**1.1 ADDENDUM FORM**

- .1 This Addendum forms part of the Contract Documents and modifies the Bidding Documents dated August 20, 2018, with amendments and additions noted below.
- .2 Acknowledge receipt of this Addendum in the space provided in the Bid Form. Failure to do so may disqualify the Bidder at the Owner's discretion.
- .3 This addendum consists of six (6) pages plus the following list of attached drawings:

PROJECT INTERIOR RENOVATIONS  
 CONTENTS REVISED PHASING PLAN

CLIENT FEDERAL BUILDING

**2 NEW CONSTRUCTION HVAC PLAN**  
M2 1:100

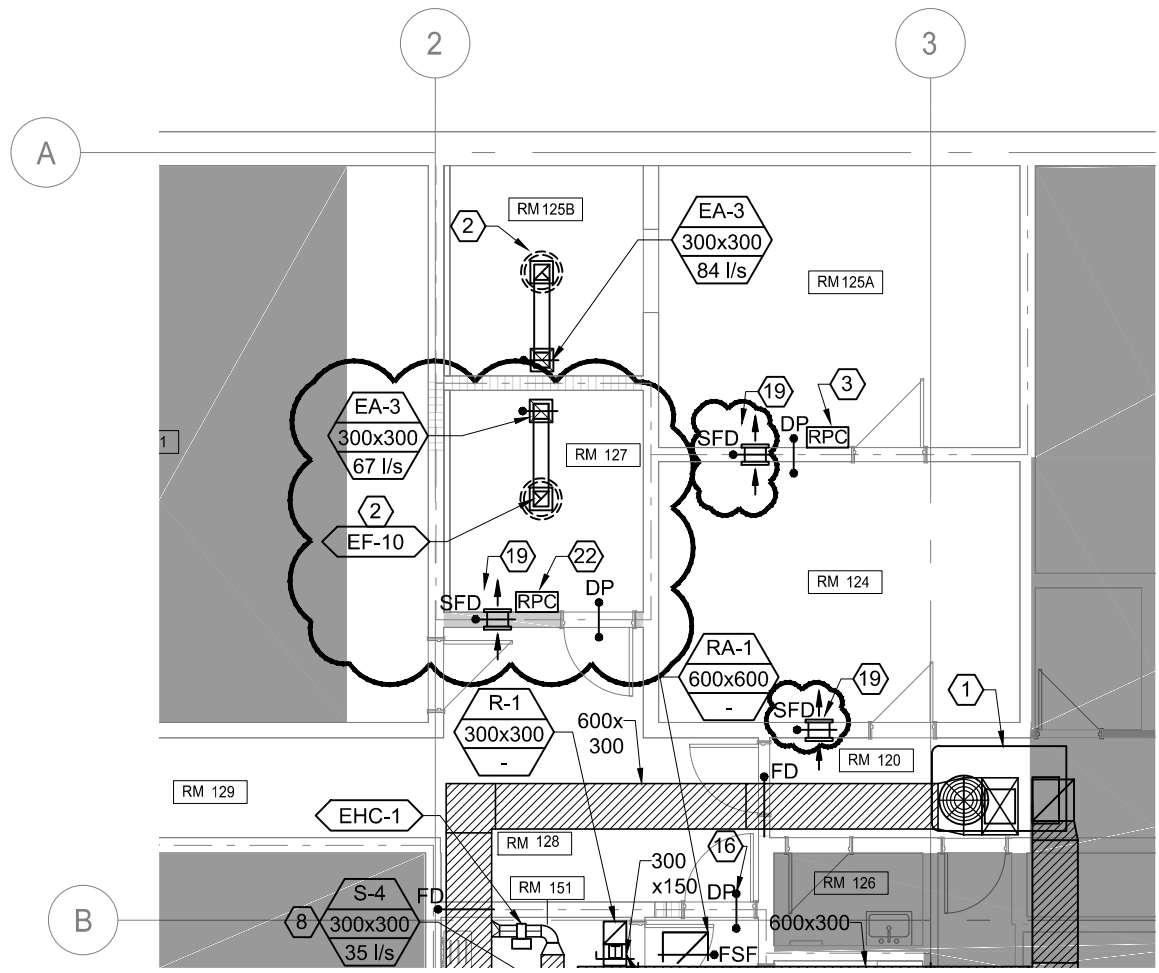
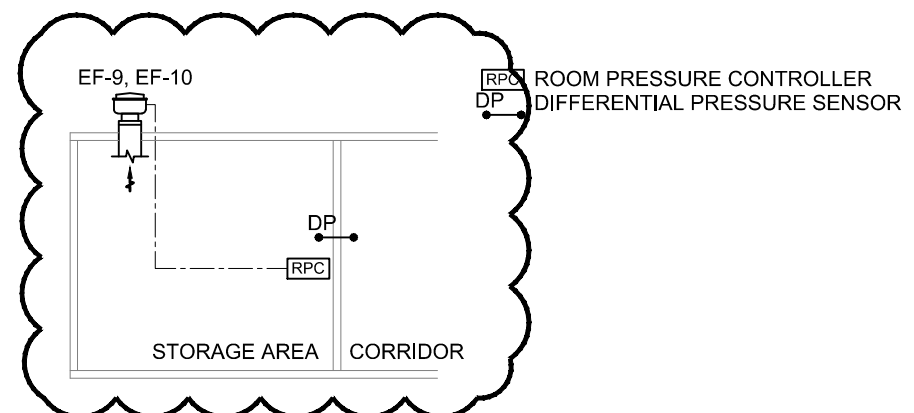
- .5 DRAWING M2R1 – New Construction Plan, Notes and Detail
  - .1 **Revise** Keynote 8.
  - .2 **Add** EF-10 exhaust fan system and controls for Rm 127.

CONTENTS MECHANICAL SCHEDULES

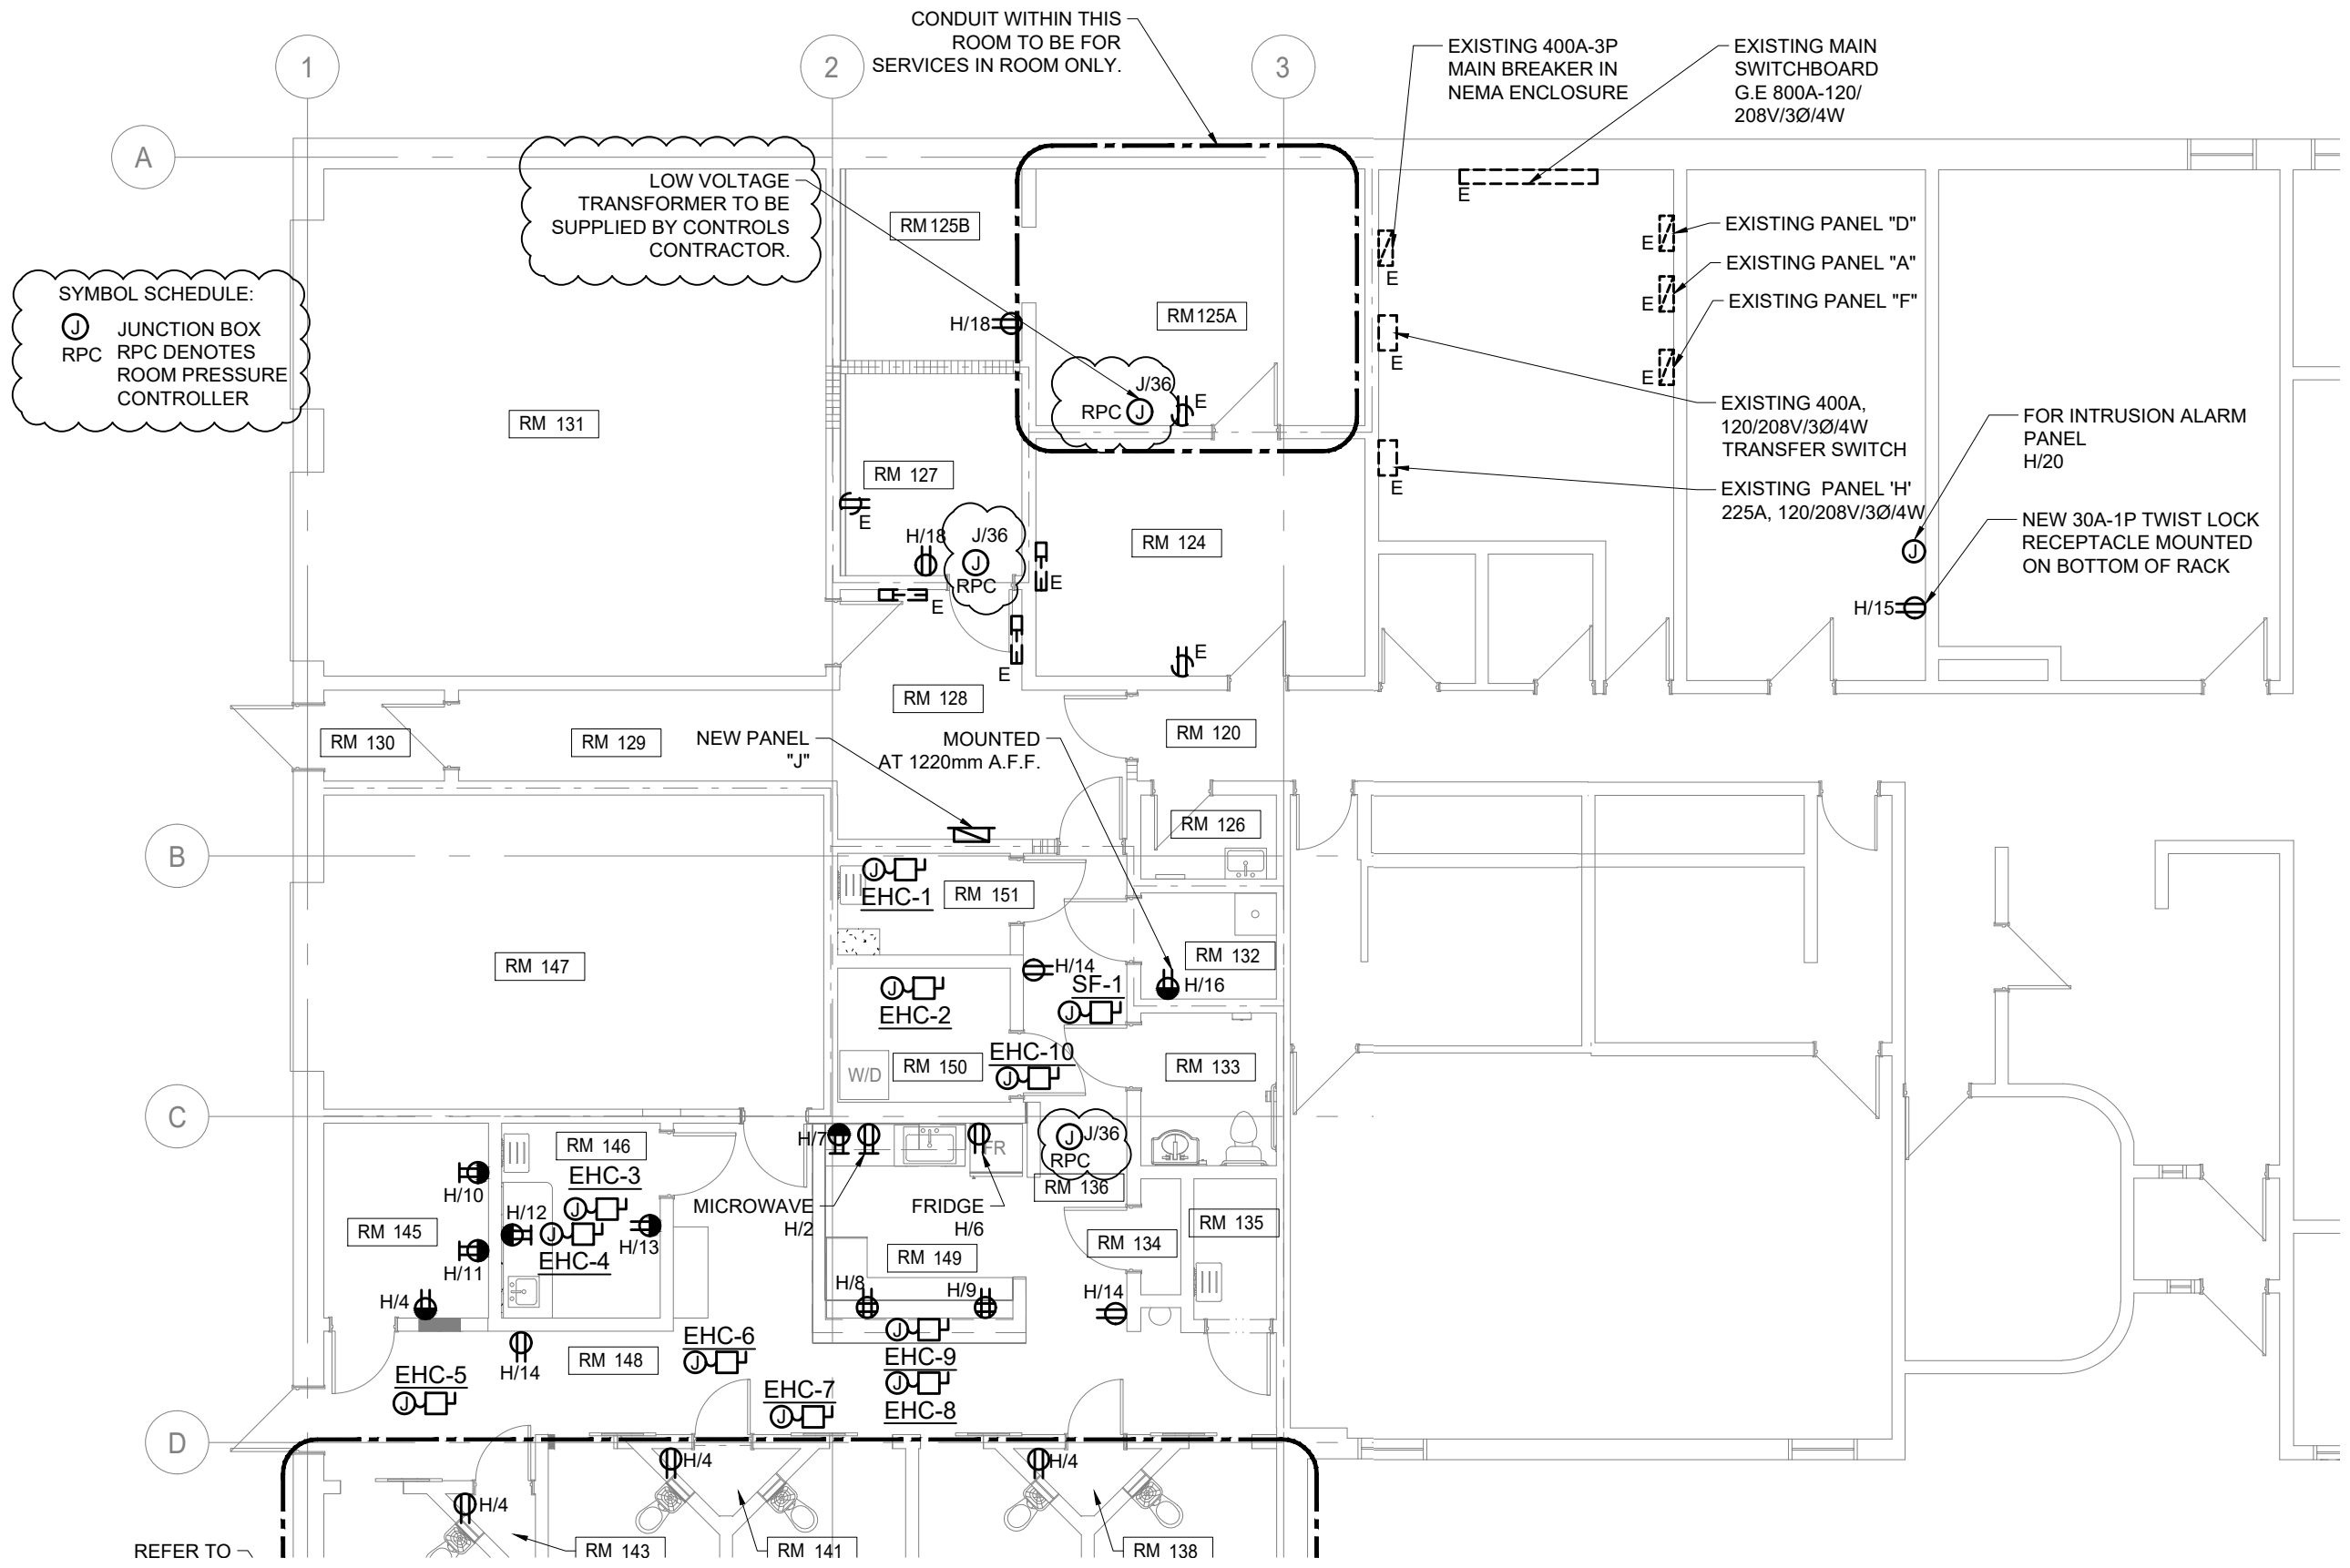
- .6 DRAWING M3R1 – Mechanical Schedules
  - .1 **Revise** schedule.
- .7 DRAWINGS E2R1A, E2R1B, E3R1A, E3R1B, E4R1, E5R1A, E5R1B, E6R1
  - .1 **Revise** controls of SF-1 and EF-9.

- .13 For the showers for Swan River there is no model number identifying which unit.  
HDK response: Refer to Drawing M3R1 as attached to this addendum.

**2** NEW MAIN FLOOR POWER PLAN  
 E2R1A 1:100

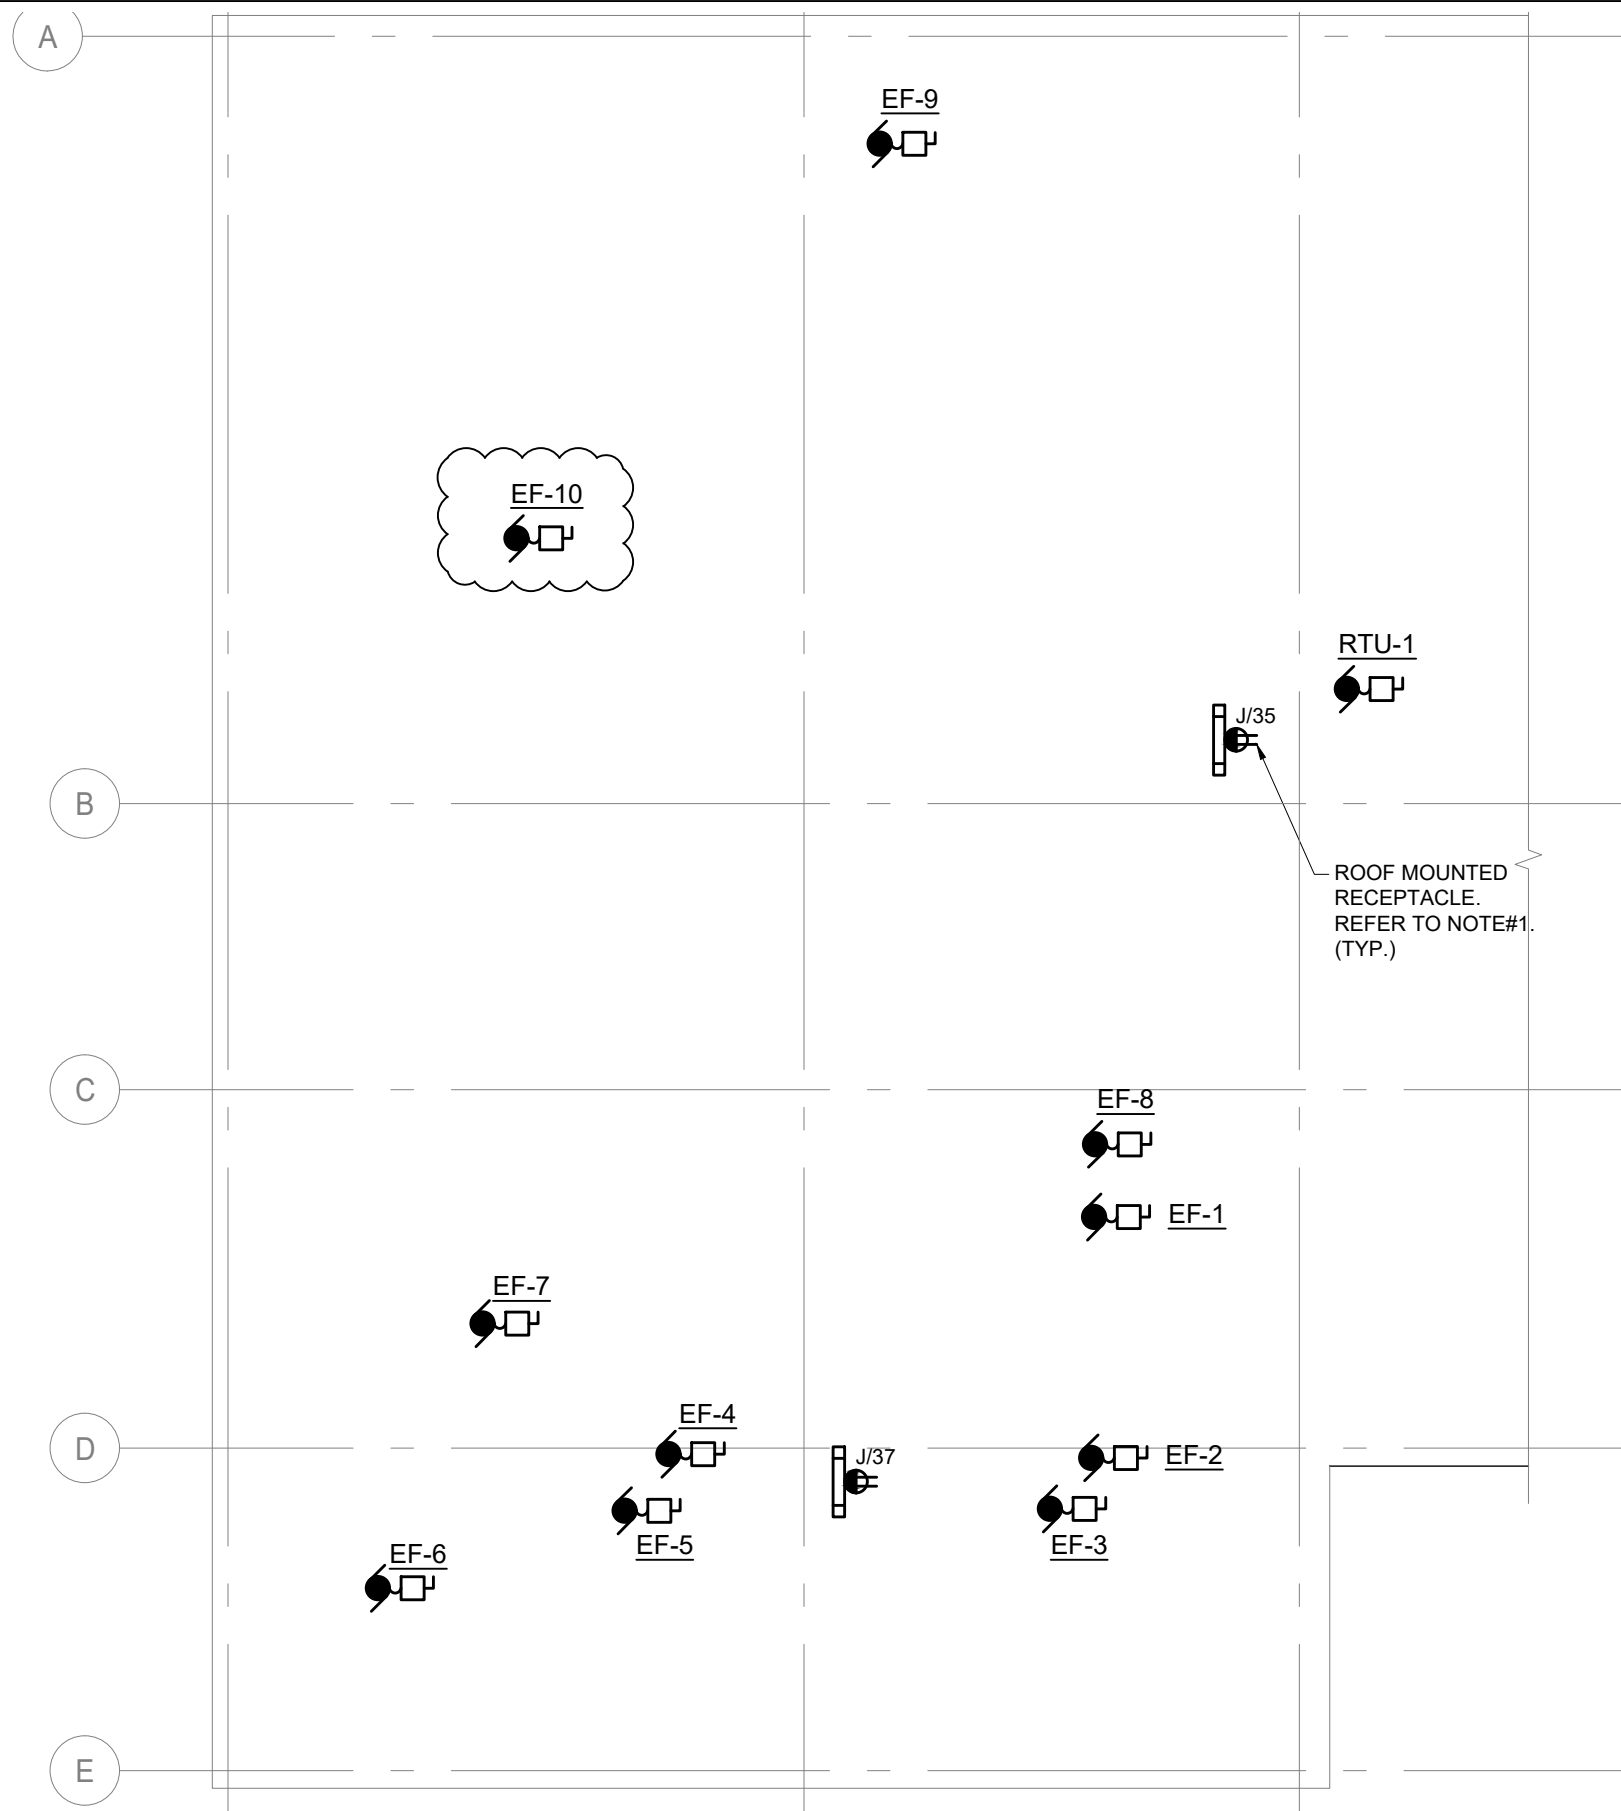
- .2 **Add** new exhaust fan EF-10.
